# **NEW BRITAIN TOWNSHIP**

# **SUBDIVISION & LAND DEVELOPMENT APPLICATION**

Pursuant to your request, Gilmore & Associates, Inc. has reviewed the Minor Subdivision Plan for the above-referenced project. We offer the following comments for consideration by New Britain Township:

**Response to Comments**

**EXISTING FEATURES** PLAN

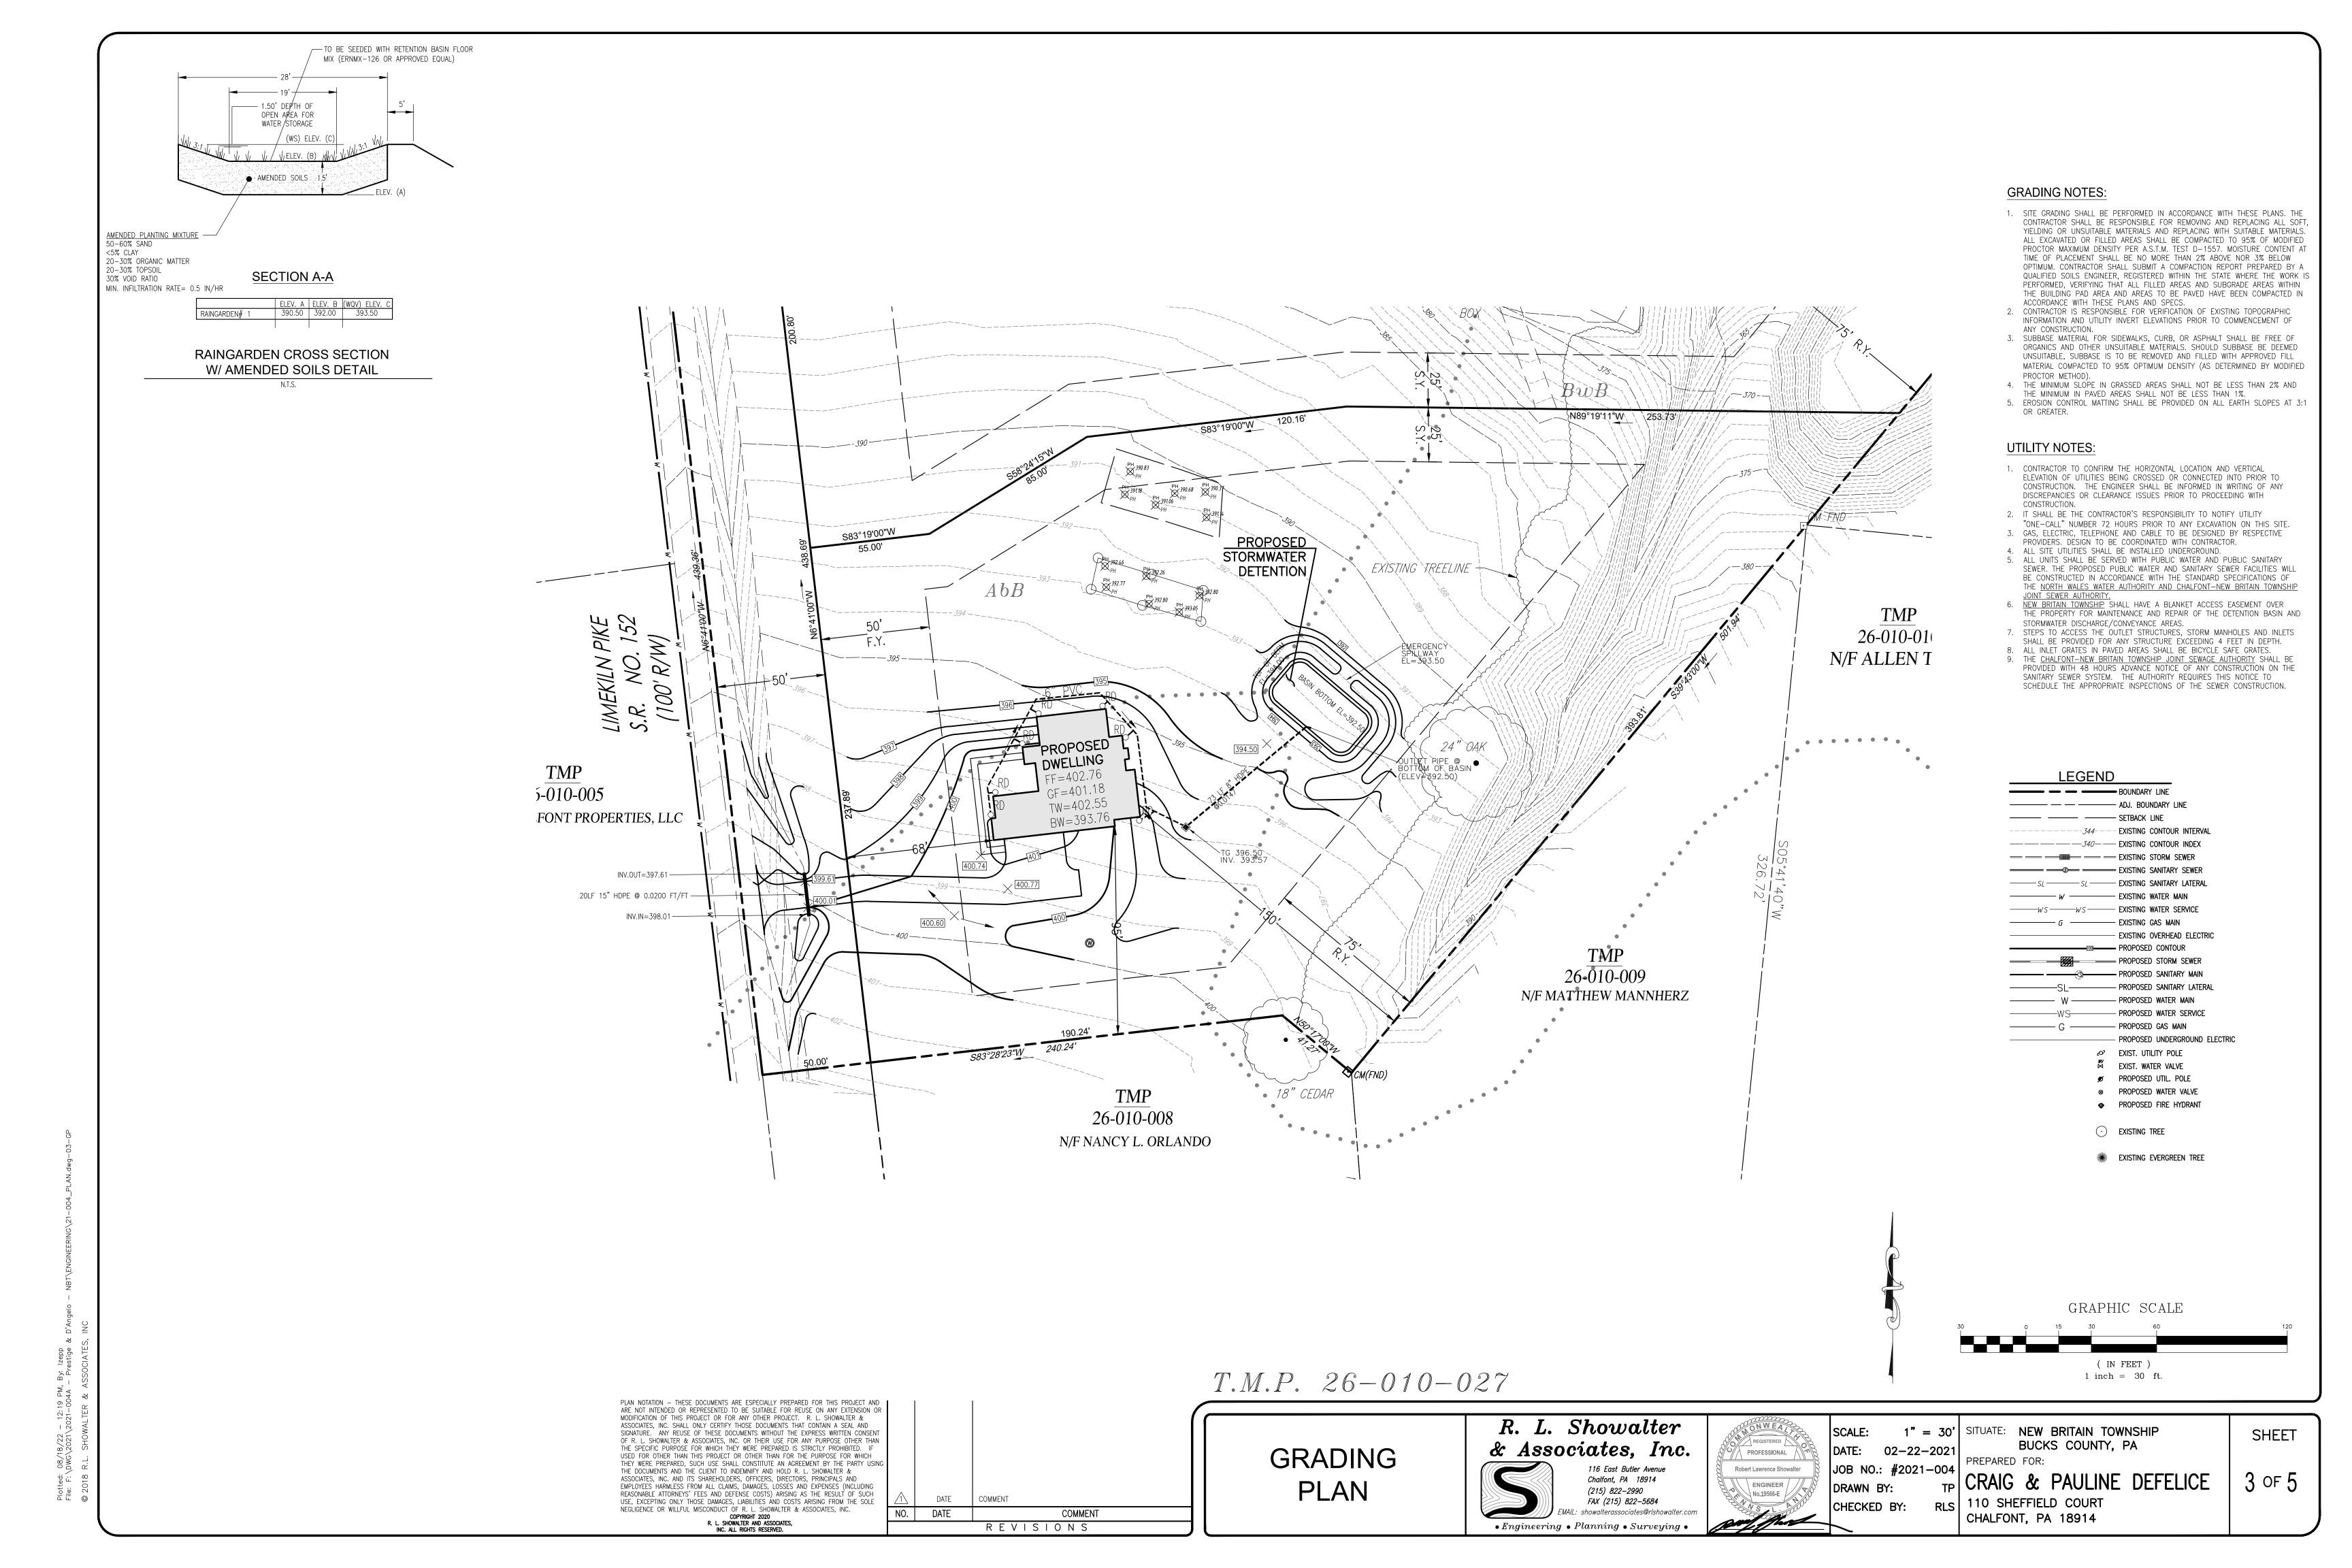
- c. Tie in bearings and distances should be provided from a property corner to the backup septic site easements on Lots 1 and 2.
  - d. The width of the S. Limekiln Pike cartway shall be dimensioned on the plan.

- g. Add the BCPC File number.
  - h. Show clear sight triangle for new driveway.
- 3. §22-502.1.B.(10) A copy of a recorded shared access easement shall be provided to the Township for the Lot 1 driveway crossing through TMP 26-010-028.

TYP. DRIVEWAY PAVING SECTION (ON-LOT ONLY) NOT TO SCALE

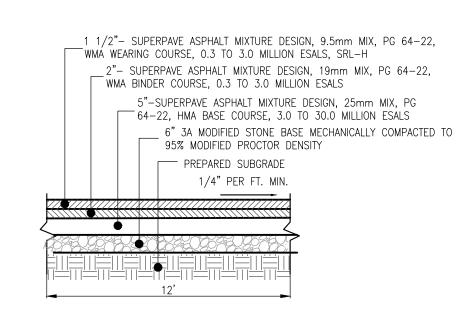
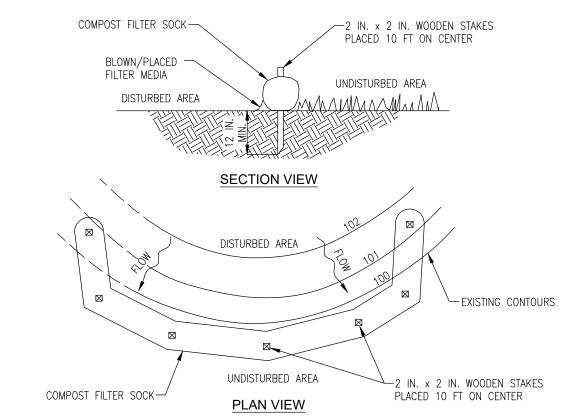
- 8. §22-705.13.C&D Residential driveways shall have a minimum width of 12 feet. The width of the driveway shall be noted on the plan. In addition, all driveways shall be provided with a stopping area of 20 feet, at a maximum grade of 3%, measured from the edge of cartway. This area shall be detailed or noted on the plans.

SKETCH PLAN OF DUNKIN DONUTS/PAPA JOHN'S

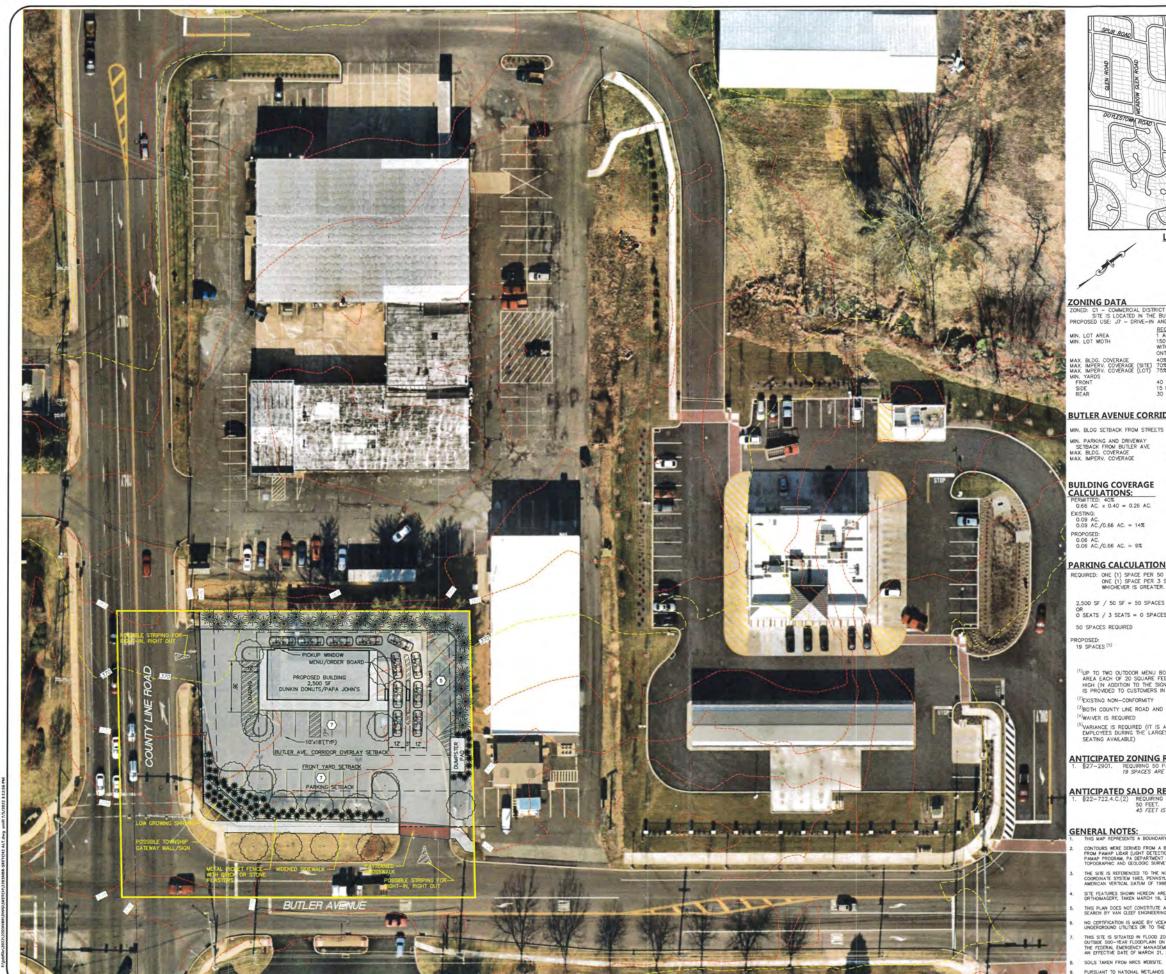
- 4. §27-2600 We defer review of the location, size and general construction of any proposed signage to the Township.
- 5. §27-2901 The proposed J7 use requires 1 parking space per 50 square feet of public area. Based on a building area of 2,500 square feet, 50 parking spaces are required. The Applicant has indicated they will request a variance to provide less than the required number of spaces. Sheet 1 proposes a total of 23 parking spaces and the Alternate Sketch Plan, Sheet 2, proposes a total of 19 spaces.
